APPLICATION NO.	FILING DATE	FIRST NAMED INVENTOR	ATTORNEY DOCKET NO.	CONFIRMATION NO.
09/529,128	06/30/2000	GRAHAM FRANCOIS DUIRS	42341-350041	2910

<b>Office Action Summary</b>	<b>Application No.</b> 09/529,128	<b>Applicant(s)</b> DUIRS, GRAHAM FRANCOIS	
	<b>Examiner</b> ANDREW M. GILBERT	<b>Art Unit</b> 3767

## **DETAILED ACTION**

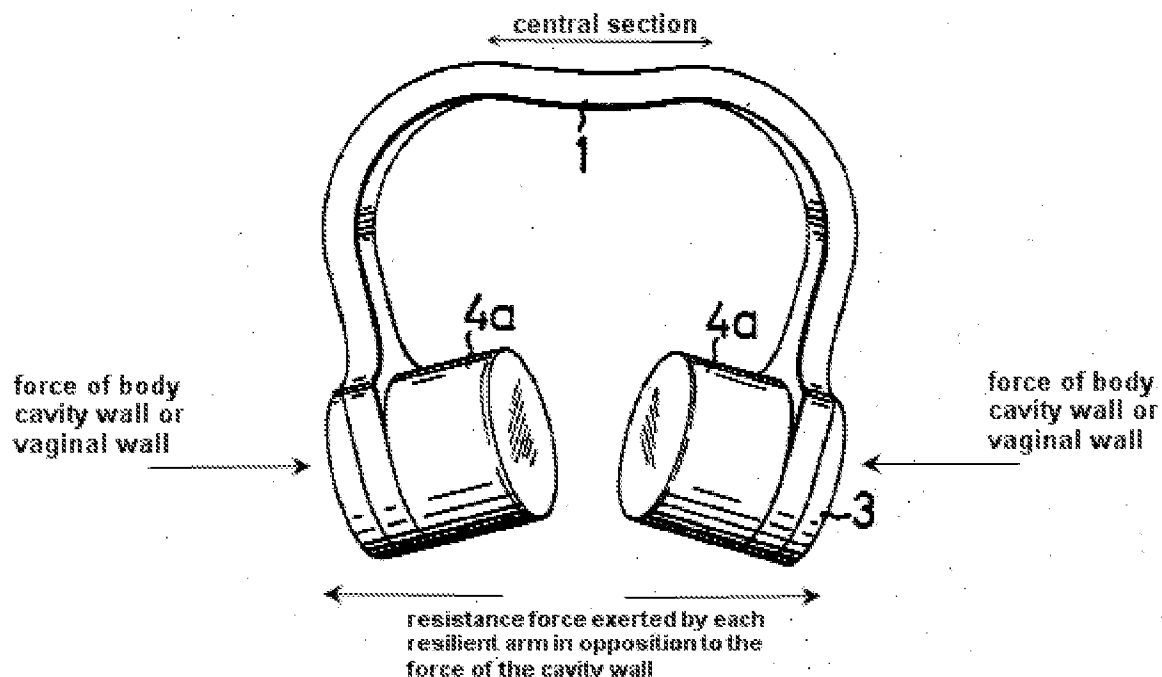
- i. Hiller et al does not disclose each distal end of the two resilient arms and pods attached to the arms being biased outward from a central section of the support frame. Rather, the distal ends of each of the arms are inclined towards each other and the pods face each other. The pods cannot be biased outward if they face each other.

14. Webster's defines "biased" as an inclination of temperament or outlook. In the present case, the baseline structure of the device when it is not in use is shown above. The applicant is correct that the arms are inclined towards each other and the pods face each other. The Examiner contends that because the arms are resilient, with respect to the central section of the support frame the arms are fully capable of being biased in two directions. The first, inwards towards each other like a clip, is the embodiment discussed in length in Hiller. During use, the arms are spread outward apart from each other to insert into the nasal septum and then released so that they return to their normal state clamping on the nasal septum and securing the device in the cavity. The second, is the reverse. The device of Hiller is fully capable of being inserted into a body cavity, such as the vagina but for exemplary purposes lets assume the nasal cavity – a cavity smaller in size than the device's non-use structural state, to an extent where the device is squished, the resilient arms are pushed inwards decreasing the width of the device during insertion and then released. The resilience of the arms will attempt to return to their standard state, an inclination to return to its non use state. In such an attempt, the arms will be biased outwards attempting to return to the standard state and exerting a force on the cavity wall securing the device in place.

15. Hiller et al does not a pictorial embodiment of the ball and socket pods disclosed in col 3, lns 8-11; however, the pods are attached to the arms which are biased outward and are thus also biased outwards and thus meet the claim limitations. Further, the ball and socket pods allow for 3-d motion of the pods and are fully capable of allowing the pods to contact the walls of the body cavity or vagina.
